Detailed Site Plan Alternative Compliance Spirit of God Deliverance Church

DSP-21012 AC-21020

SUBJECT: Detailed Site Plan DSP-21012 Type 2 Tree Conservation Plan TCP2-043-2021 Alternative Compliance AC-21020 Spirit of God Deliverance Church

Figure 2: Architectural Elevations

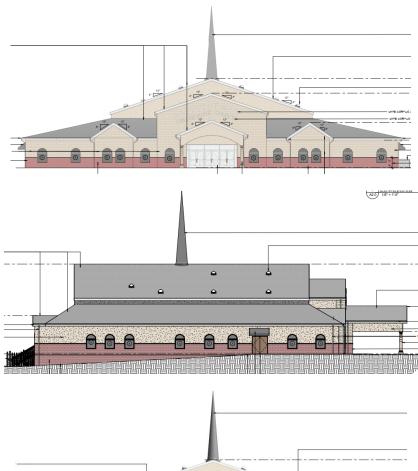
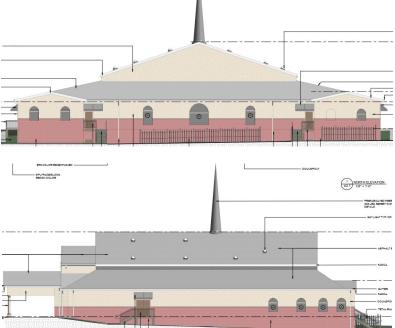
The proposed approximately 36-foot-tall church will be finished mostly with split-face block in red and beige colors, with beige exterior insulation finish system along the top, sides, and rear of the building. The top portion of the building will be beige with the bottom four feet being red. The gabled roof will consist of asphalt shingles and have solar tube skylights with a prefabricated fiberglass steeple at the top. The north elevation, which is the front of the building, will have 12 arched windows and a nine-foot-high canopy supported by columns with six front entrance doors. The south elevation, which is the rear of the building, will include multiple exit doors with grey colored awnings and metal railing and concrete steps and ramps leading to the ground level. The west and east elevations, which are the sides of the building, show the elevation dropping approximately five feet from the front to the rear of the building and include various windows and exit doors with awnings.

- b. Provide the height of the prefabricated steeple, include it in the dimensions located on the architectural elevations, and provide a detail of the steeple.

- c. Revise all references to the proposed height on the plan to include the height of the steeple.
 - d. Revise General Note 4 to include "Church with 500 proposed seats".
